HYDROLOGY M16/D13A OFFICE BLDG. FOR GEPT ASSOCIATES

Re: GEPT Associates- Office Building
Lot 4, Airport Business Park (M16/D13A)

RE: GRADING & DRAINAGE PLAN FOR OFFICE BUILDING FOR GEPT ASSOCIATES (M-16/D13A) RECEIVED FEBRUARY 26, 1985

STORM DRAINAGE REPORT

A-1. Volume of storage in corregations

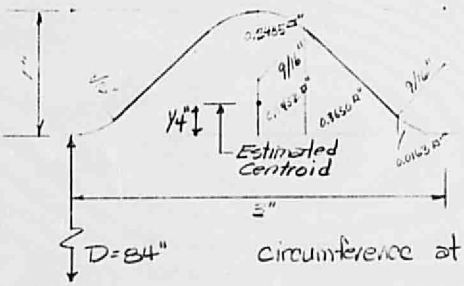
1. While I am in agreement with the proposed scheme, I do not agree with utilizing the corregations as additional volume. The size specified is nominal so this inclusion may not be appropriate.

1. The length of the 84 inch diameter pipe has been increased to account for the quantity calculated to be within the corrigations.

The following revisions are to minimize ponding due to available storm sewer capacity, parking lot ponding and volume in corrugations.

AREA PER FOOT OF PIPE =
4 x 1.4975 = 5.99 SQ IN.

Total volume per foot length = (5.99 x 265.46)/1728 = 0.9202 cu ft/ft.
